SERVICE BULLETIN SB04.01

Machines/Models: TM12 Serial Numbers: 7601 THRU 7649,7673,7677

PURPOSE: Replace platform due to insufficient powdercoat inside mast.

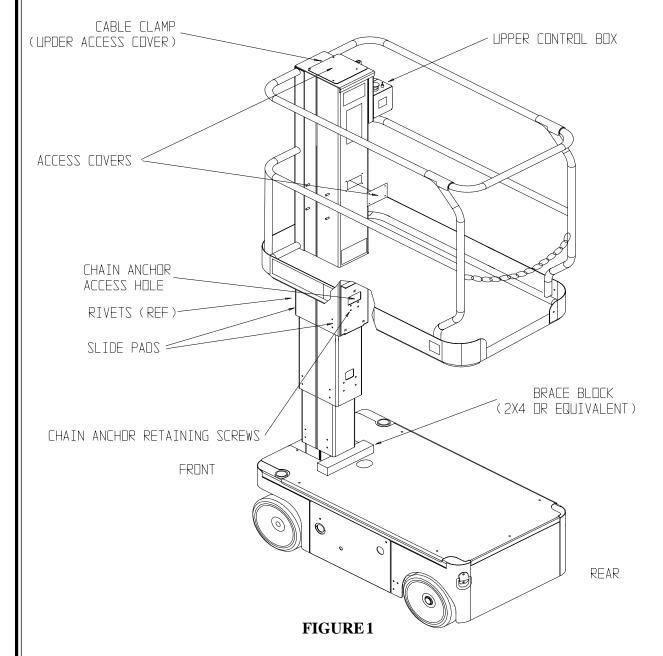
- 1. Raise platform approximately 30 inches and block the mast assembly as shown in **Figure 1**.
- 2. Disconnect batteries.
- 3. Tag and disconnect the control cable wires from inside the upper control box. Use extraction tool 031047-005 to remove harness wires from joystick connector.

- 5. Remove retaining screws from chain anchor as shown in **Figure 1**.
- 7. Remove retaining screws and pry out rear slide pads from inside the bottom of the platform mast. Drill out the four rivets from the front of mast so front pads are able to slide out when platform is removed. Note orientation of front and rear wear pads.

FIGURE 2

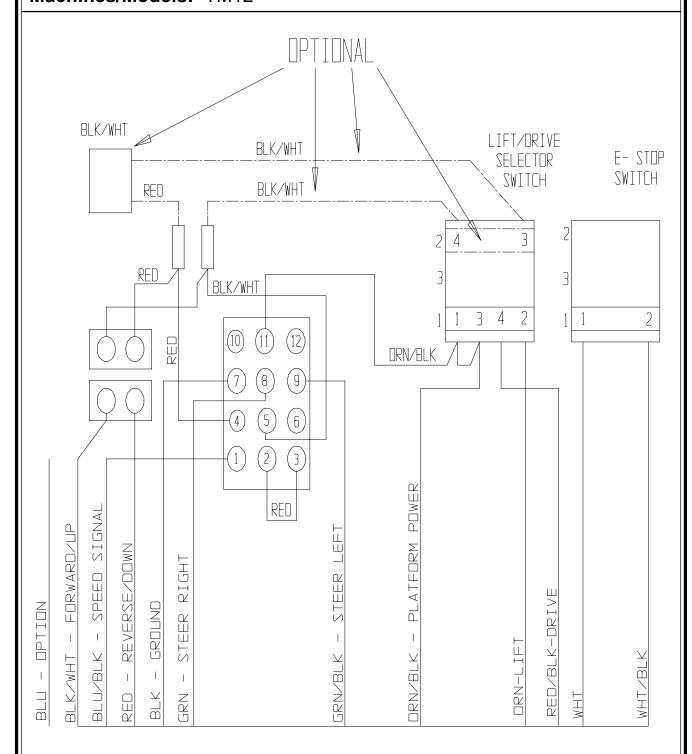
NOTE: Reference **Figure 2** for upper control wiring.
